# SERVICE BULLETIN

Classification: FE14-001	Reference: NTB14-018	Date: March 20, 2014
-----------------------------	-------------------------	-------------------------

## 2008 – 2014 ROGUE; EXHAUST CENTER TUBE HEAT SHIELD RATTLE

**APPLIED VEHICLES:** 2008 – 2013 Rogue (S35)  
2014 Rogue Select (S35)

Figure 1

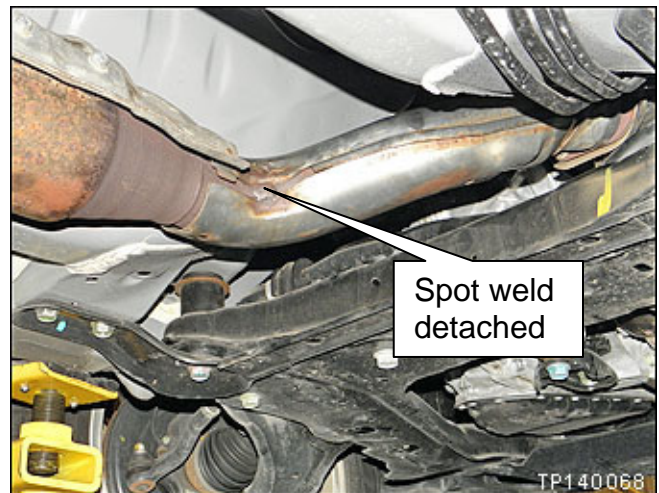
A rattle coming from the exhaust center tube heat shield,

The heat shield spot weld is detached at the location shown in Figure 1.

Install a band clamp around the heat shield and over the detached spot weld.

Figure 3

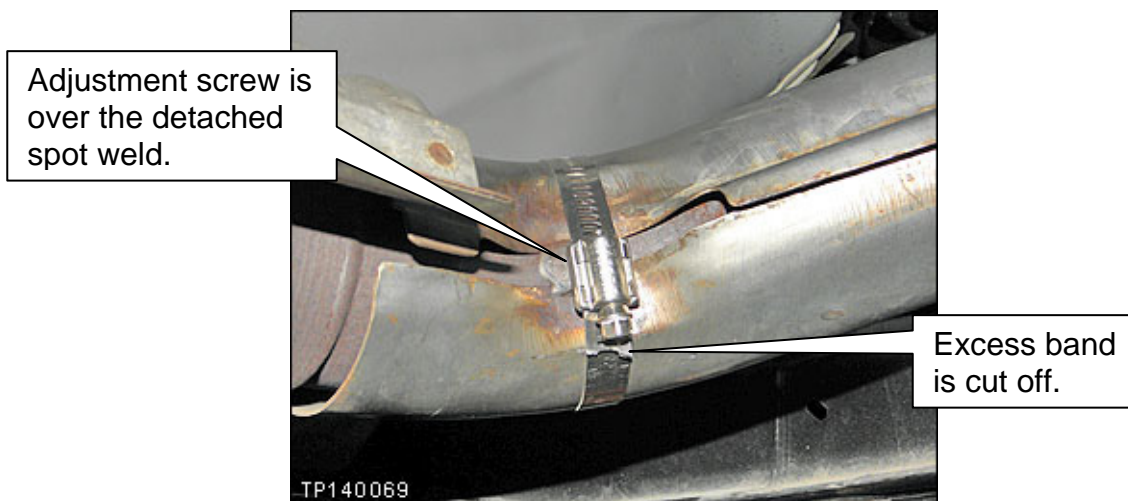
2. Install a band clamp around the heat shield and over the detached spot weld as shown in Figure 3.
  - Make sure the adjustment screw is over the detached spot weld.
  - Make sure the band clamp is tightened to 4.0-5.5 N•m (0.4-0.56 kg-m, **35-49 in-lb**).
  - Cut off excess band (leave approximately 5 mm [1/4 inch] of excess band).
